Lloyd's Register of Shipping.

Ship's Name PLAVNIKOfficial No. 86

Memorandum of alterations reported since ship was surveyed for assignment of Load Lines in accordance with Wokingham letter to New York dated March 12, 1943

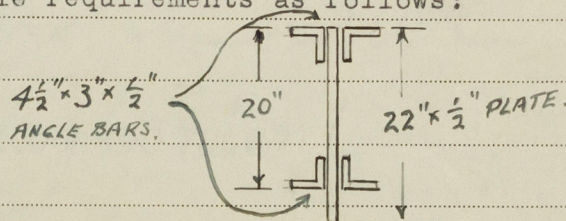
Nos. 2 and 3 hatchways on freeboard deck have 2

hatchways beams each spaced 9'6" as per sketch

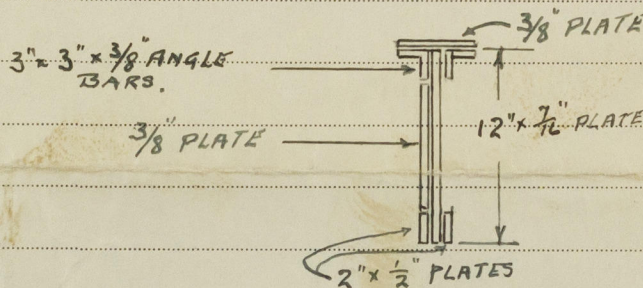
Nos. 2 and 3 hatchways on the bridge deck and freeboard deck and No. 4 hatchway on the raised quarter deck have 3 fore and afters each spaced 5'-1-1/2" as per sketch

unsupported lengths are 8'9"
